LAW SUBDIVISION

Revised for the September 6th meeting:

APPLICATION NUMBER 6 DATE September 6, 2007

DETAIL SITE PLAN

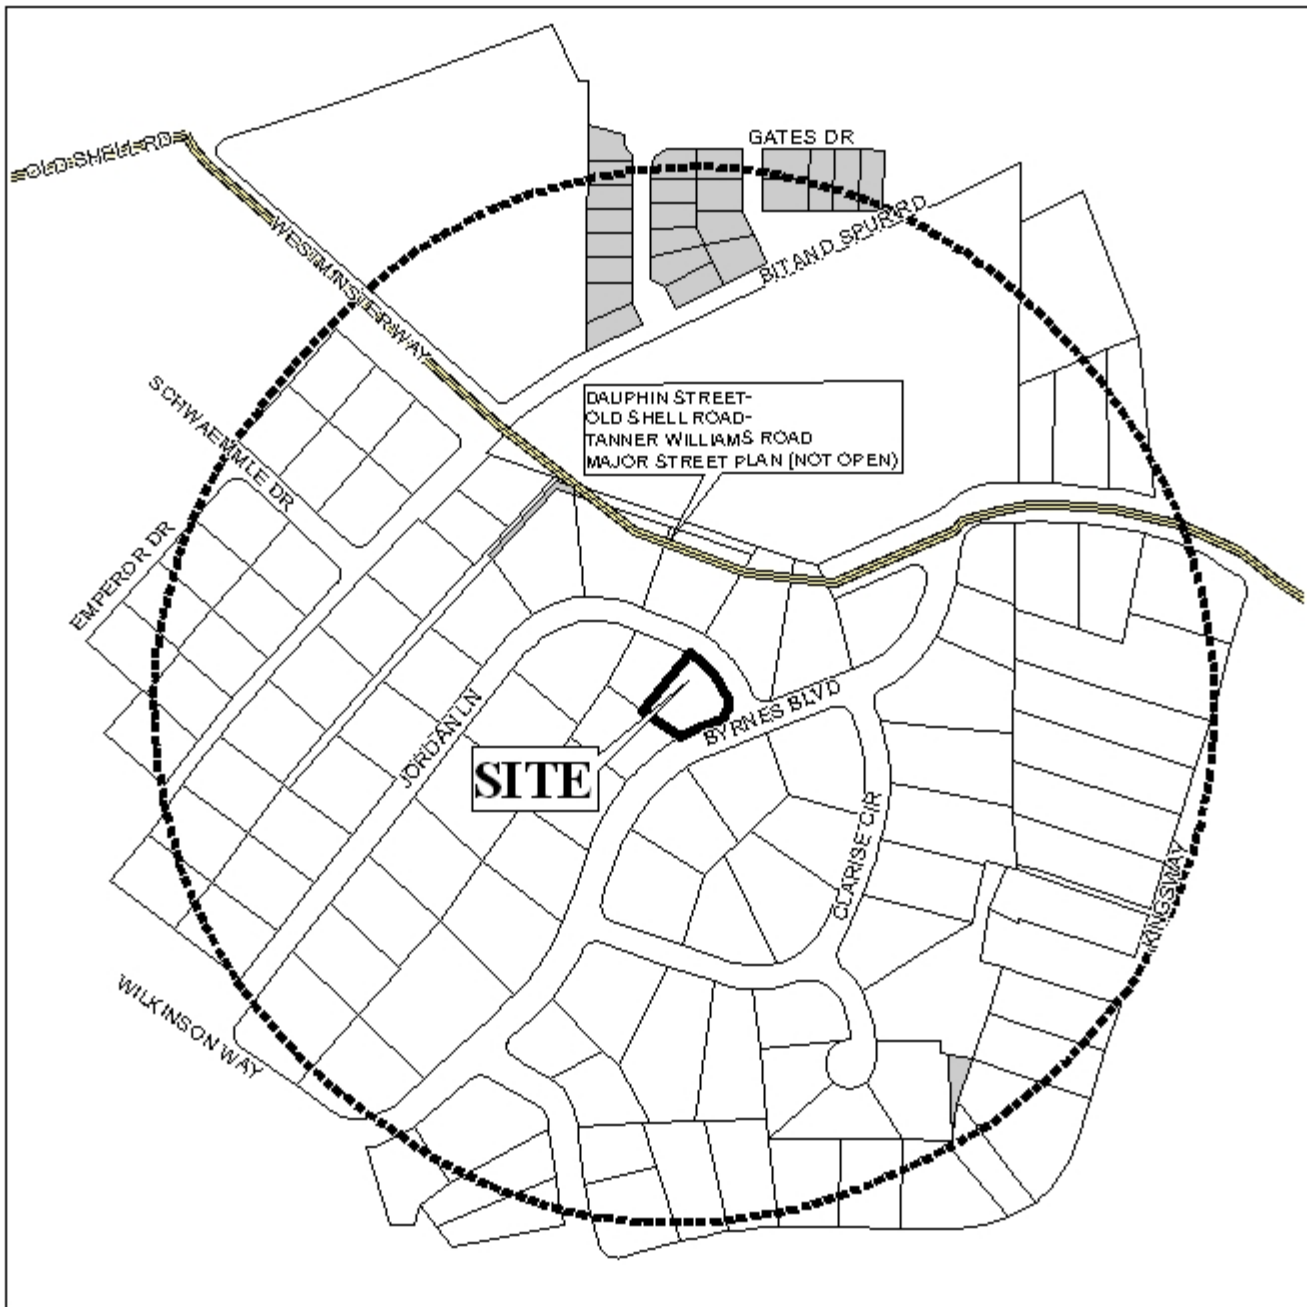
The plat illustrates the proposed $0.4 \pm$ acre, 2-lot subdivision which is located at the Northwest corner of Byrnes Boulevard and Jordan Lane. The applicant states that the subdivision is served by public water and sewer facilities. The site is located in Council District 5.

The site fronts onto Byrnes Boulevard and Jordan Lane, both minor streets with adequate right-of-way. Due to the size of the proposed lots, each lot should be limited to one curb-cut each, with the size, design and location to be approved by Traffic Engineering, and in compliance with AASHTO standards.

Each proposed lot will meet the minimum size and dimensional requirements of the Subdivision Regulations, however, they will be somewhat uncharacteristic of the general area due to their relatively small size. Proposed Lot 1 will be 10,402 square feet, and proposed Lot 2 will be 7,207 square feet. Of the 55 single-family residential lots / parcels within 600 feet of the site, none are less than 13,000 square feet in size. The average size of all lots / parcels is approximately 27,400 square feet.

- 1) The size of the lots would be uncharacteristic of the area, per Section V.D.1. of the Subdivision Regulations.

- 1) Placement of a note on the final plat stating that each lot is limited to one curb-cut, with the size, design and location to be approved by Traffic Engineering and conform to AASHTO standards; and*
- 2) full compliance with all other municipal codes and ordinances.*
